United States Department of the Interior
OFFICE OF SURFACE MINING
Reclamation and Enforcement
BROOKS TOWERS
1020 15TH STREET
DENVER, COLORADO 80202

**PRICE RIVER MINE COMPLEX
TECHNICAL AND ENVIRONMENTAL ASSESSMENT**

DRILL HOLE MC-6

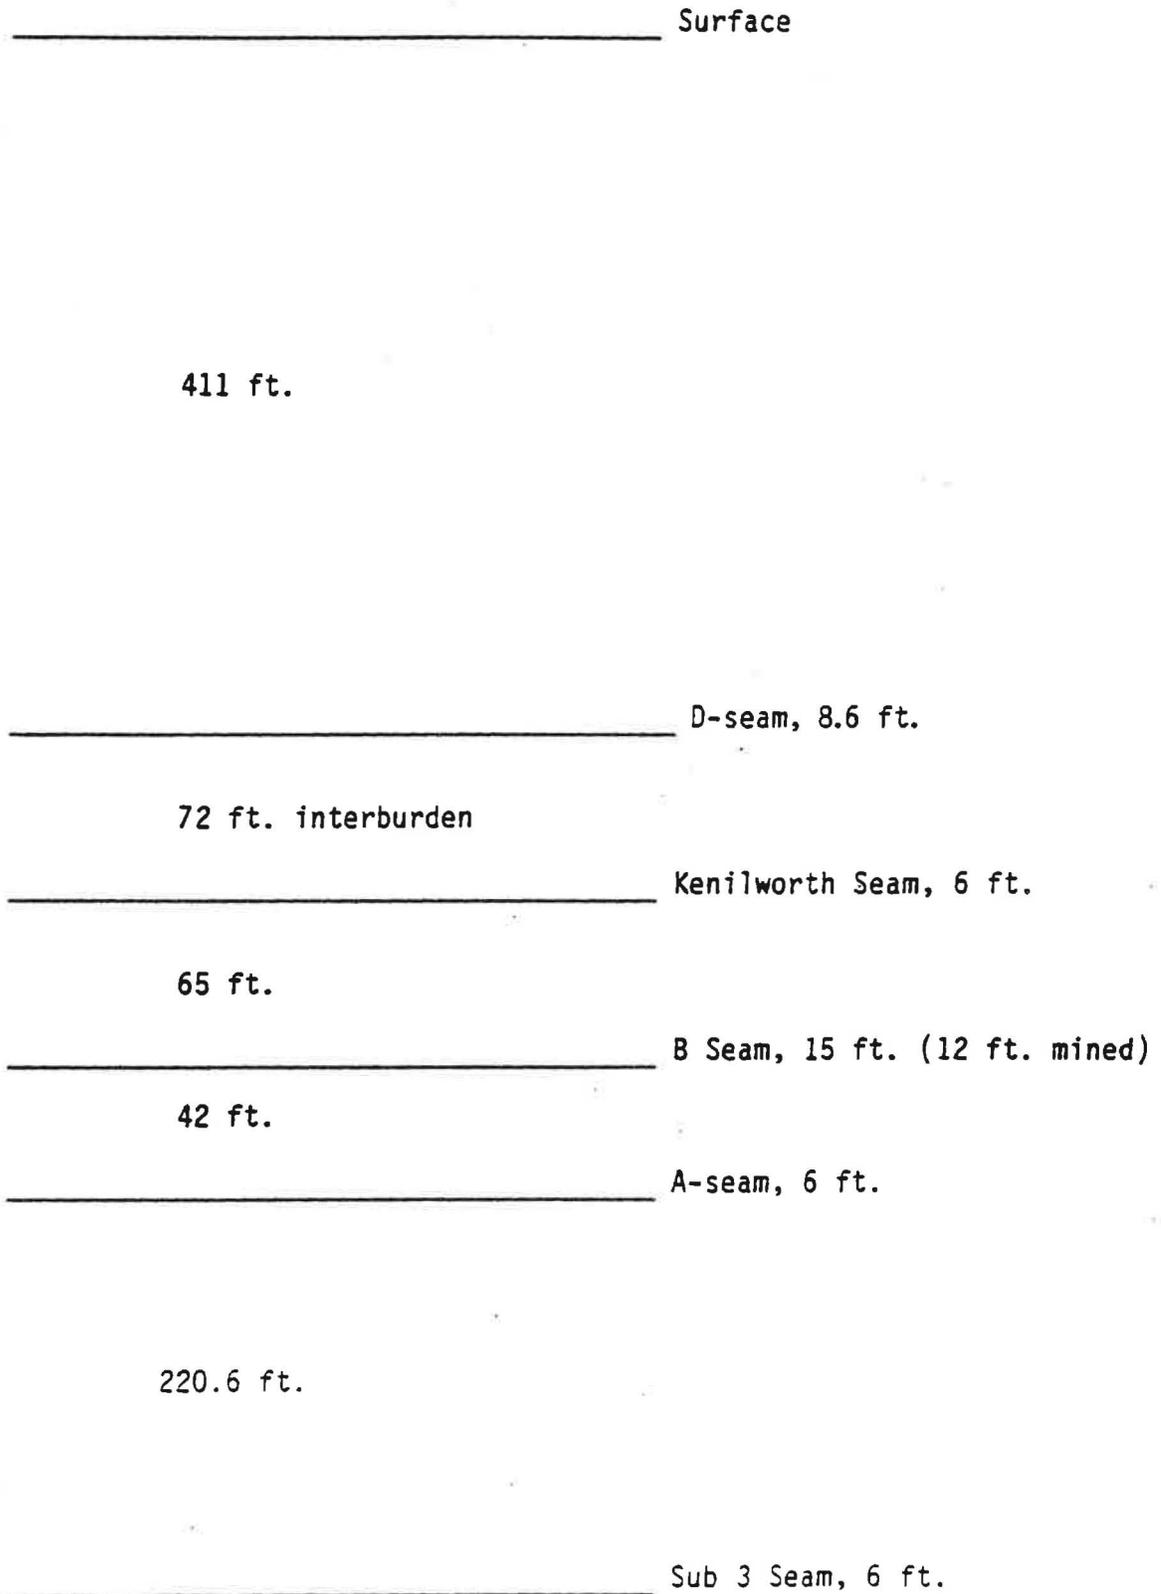
DRILL HOLE MC-52

Although this hole was not drilled through the Aberdeen to the Sub 3 Seam, the occurrence of the Aberdeen is very consistent throughout this area. Detailed lithologic information was submitted for three other drill holes and in each of these holes, the Aberdeen sandstone existed.
